Agenda
Village of Arlington Heights
Design Commission
Community Room, 3rd Floor

Arlington Heights Village Hall
33 S. Arlington Heights Road
Arlington Heights, IL 60005
August 14, 2018
6:30 PM

STAFF DESIGN COMMISSION REPORT

Project Name: Sieron Residence
Project Address: 734 N. Chestnut Ave.
Prepared By: Steve Hautzinger

EXTERIOR
ELEVATIONS
A3A

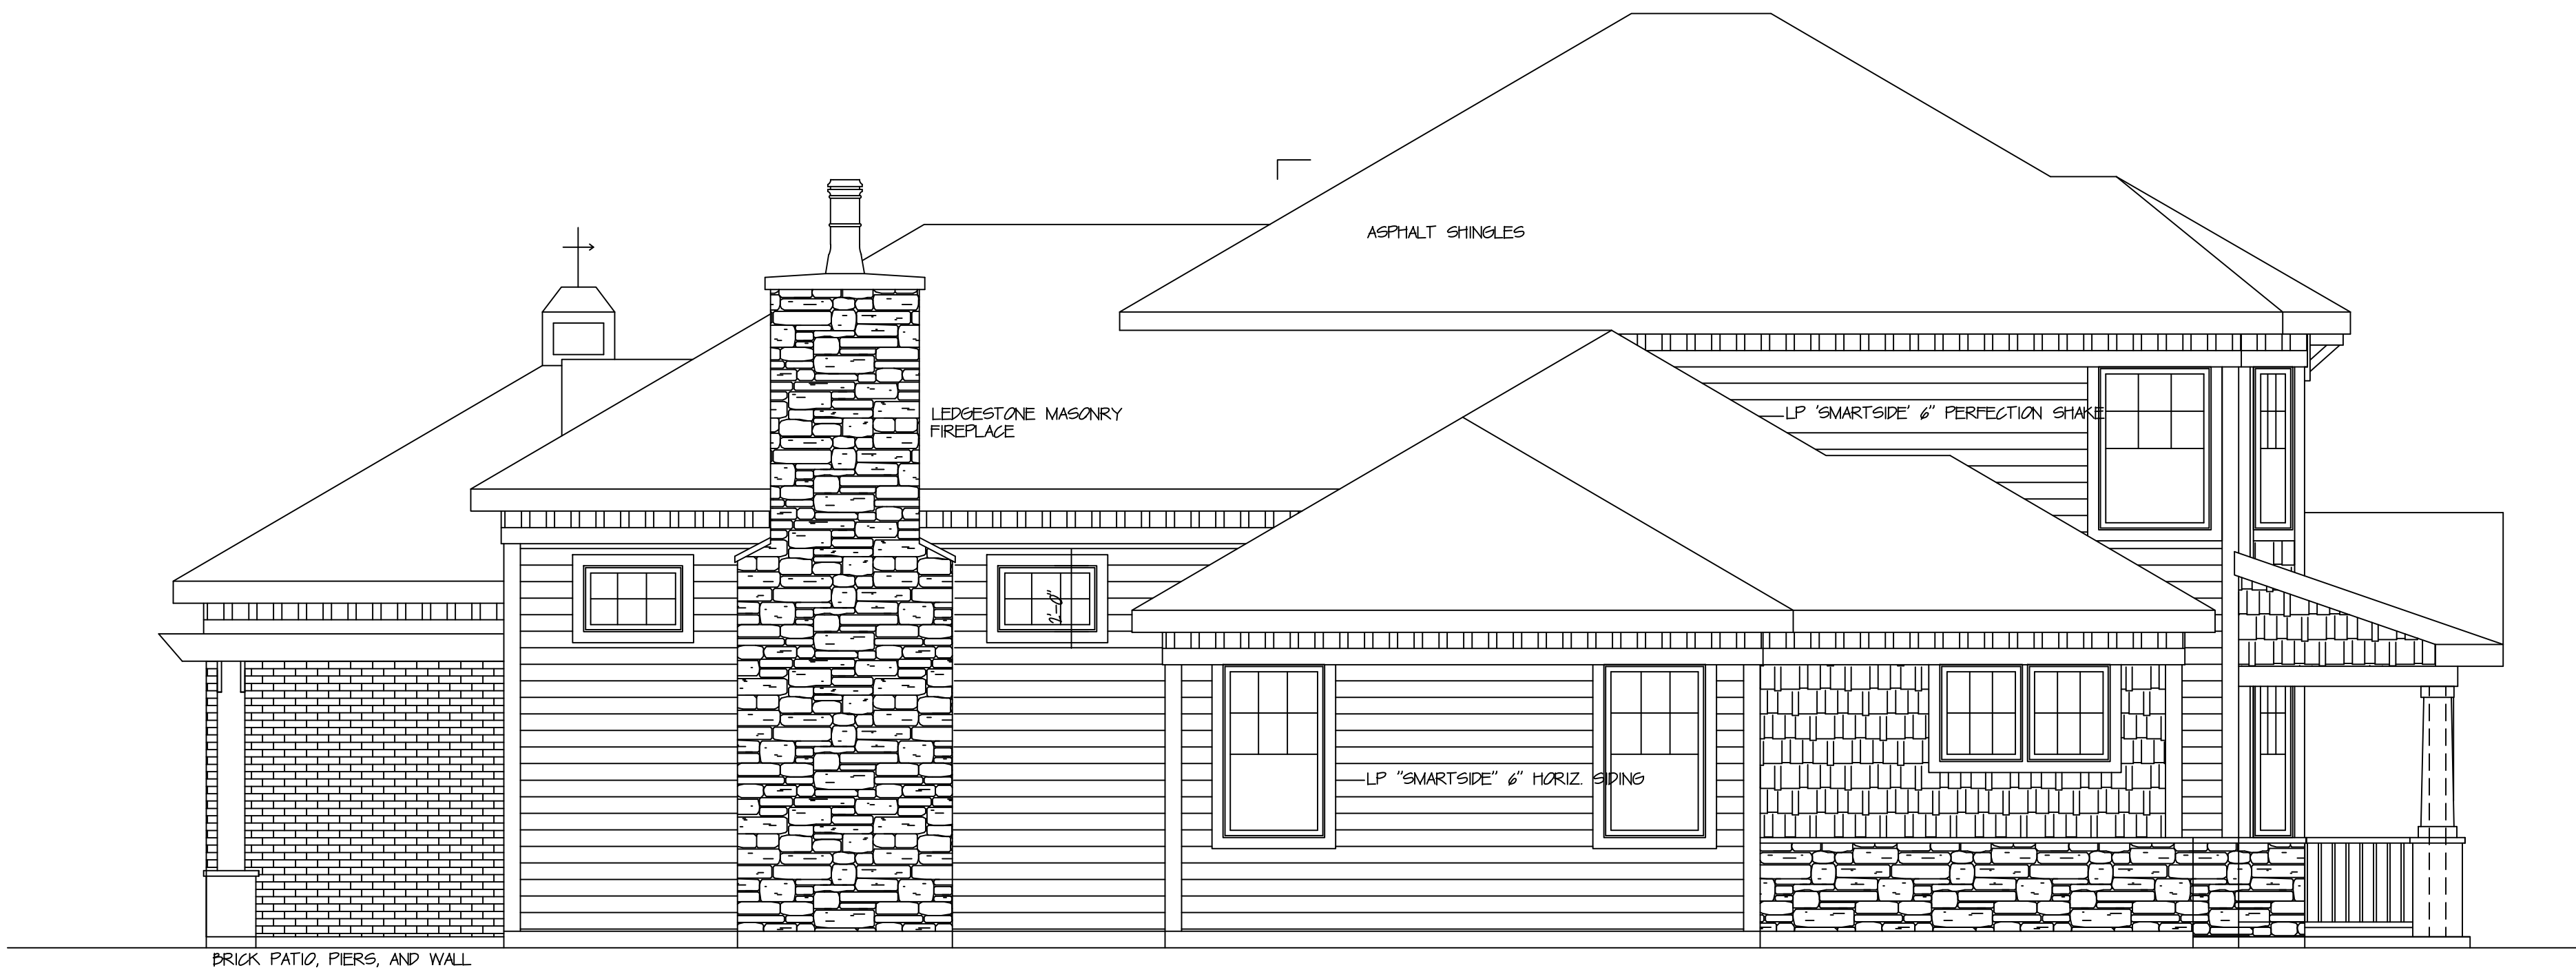
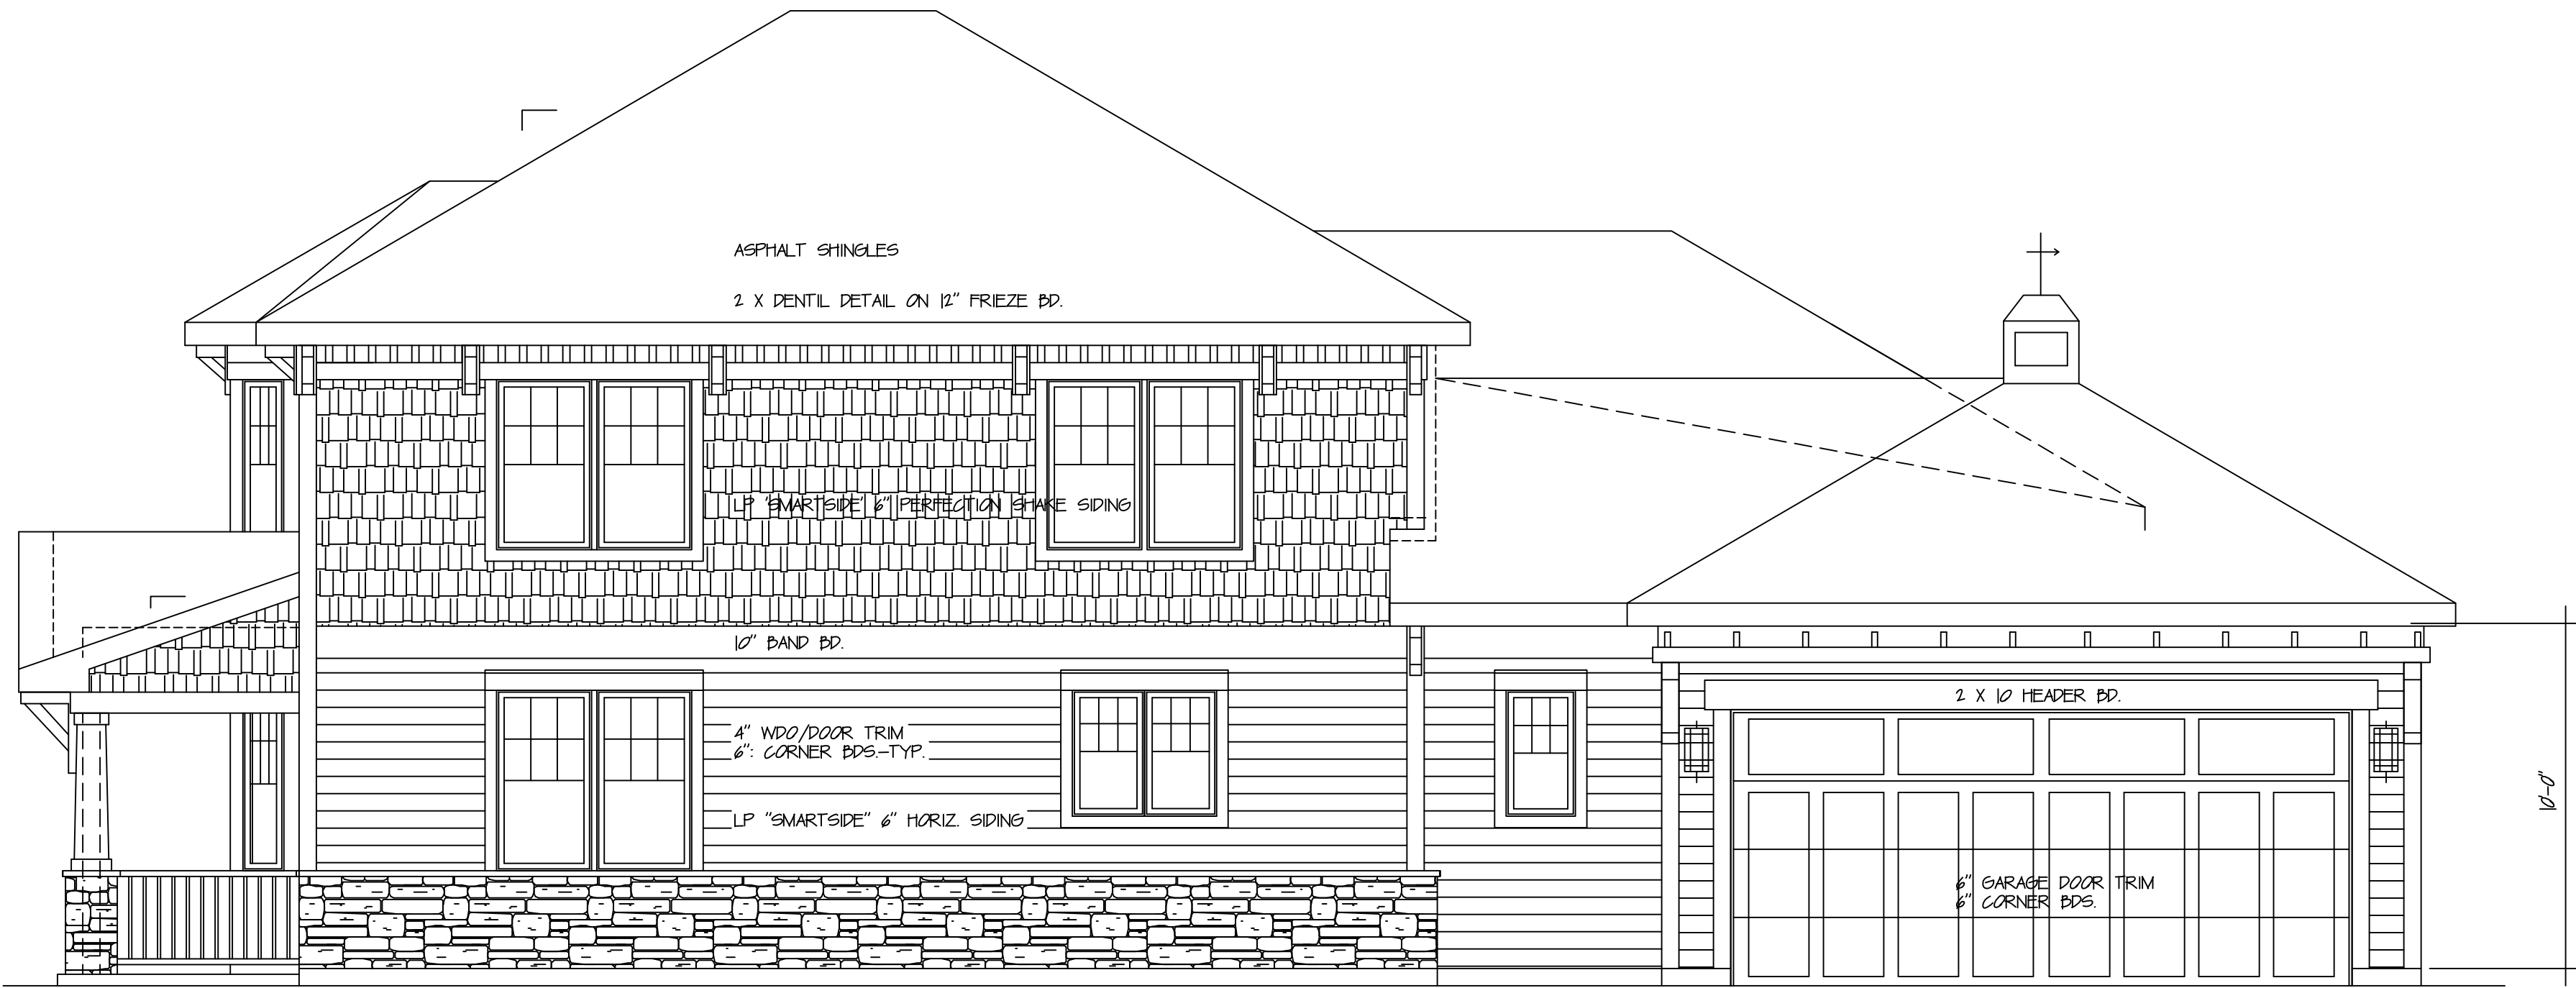
In regards to the proposed new house, the design has a very nice traditional appearance that will fit well in this location. The overall massing and combination of materials is nicely done, and the placement of the new attached garage (facing the exterior side) is ideal. Raising the first floor a few steps above grade is encouraged to give the design an even more authentic appearance. A minor comment on the design is that the oval window above the front door looks sideways, and it is recommended that it be rotated to a vertical orientation.

1. Evaluate the option to restore and expand the existing house.
2. Consider raising the first floor of the new house a few steps above grade.
3. It is recommended that the oval window be rotated to a vertical orientation.
4. This review deals with architectural design only and should not be construed to be an approval of, or to have any other impact on, any other zoning and/or land use issues or decisions that stem from zoning, building, signage or any other reviews. In

FRONT ELEVATION
SCALE: 1/4" = 1'-0"

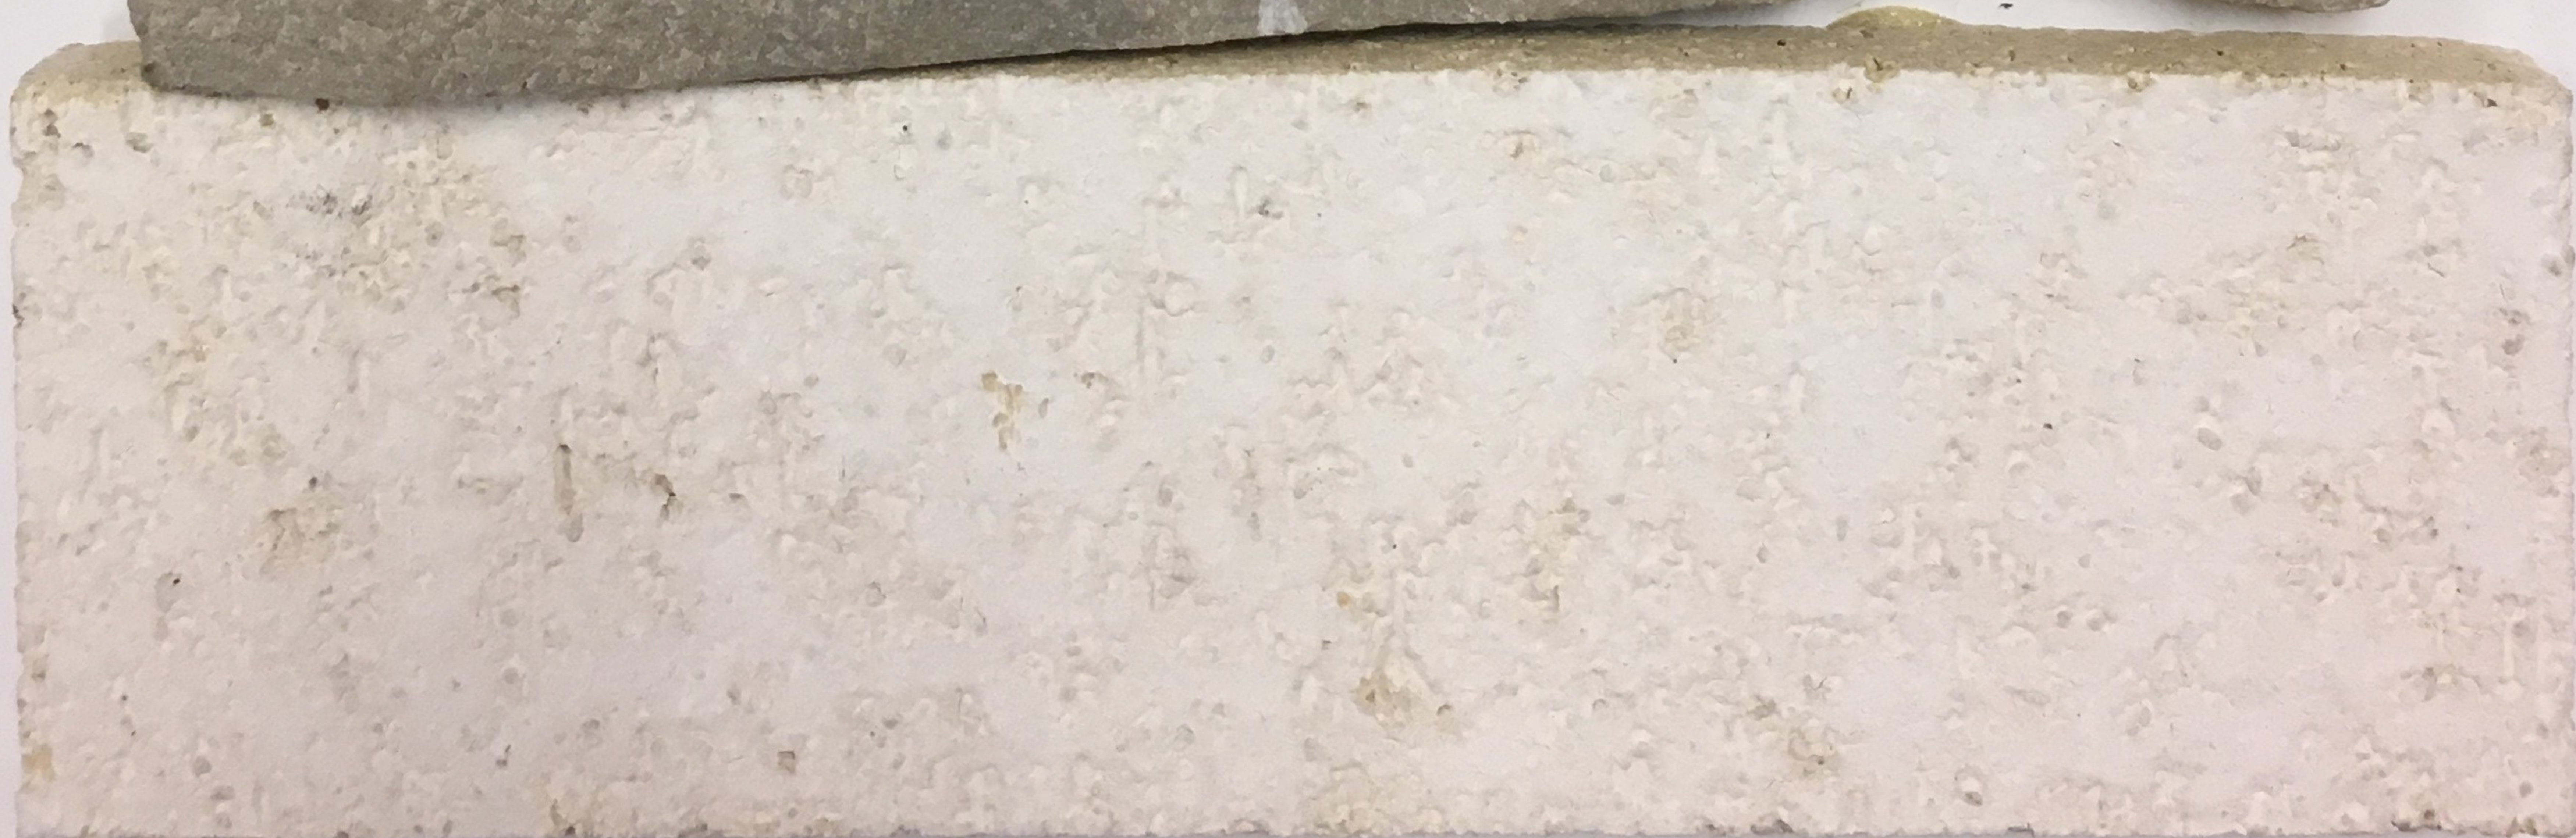
The proposed house is large, but the overall massing generally fits with the scale of the adjacent newer homes. However, the proposed front entrance design has a very grand scale and appearance that does not fit the character of the neighborhood. The large front entrance has a more commercial appearance, such as a church or banquet facility. The Design Commission should evaluate the proposed design for compatibility with the character of the area.

1. Evaluate the character and scale of the front entrance with the character of the area.
2. This review deals with architectural design only and should not be construed to be an approval of, or to have any other impact on, any other zoning and/or land use issues or decisions that stem from zoning, building, signage or any other reviews. In addition to the normal technical review, permit drawings will be reviewed for consistency with the Design Commission and any other
